AMENDMENT UNDER 37 C.F.R. § 1.111
U.S. Application No. 10/767,209

AMENDMENTS TO THE DRAWINGS

Fig.4

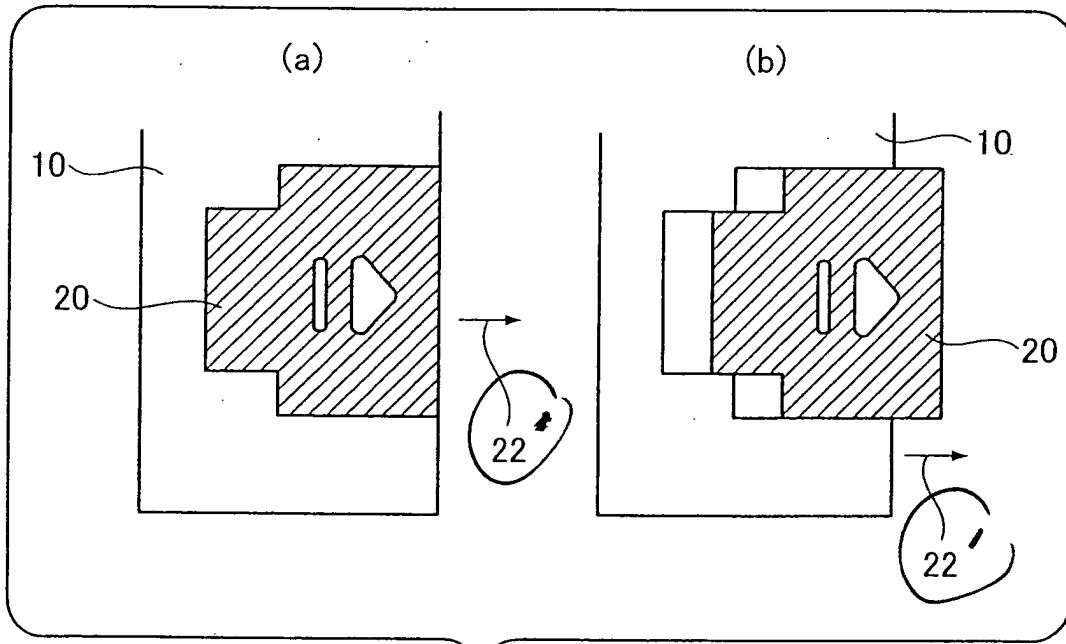
Figure 4 has been corrected to denote the arrow with reference numeral --22'--, and Figure 7 has been corrected to denote the hole 22 instead as --22"--.

With respect to the drawings, in Figures 3 and 4, both “arrow 22” and “engagement section 22” use the same reference numeral. Moreover, in Figure 7, “hole 22” also utilizes the reference numeral 22.

In this regard, the drawings have been corrected to denote the arrow with reference numeral --22’-- and denote the hole 22 in Figure 7 as --22''--.
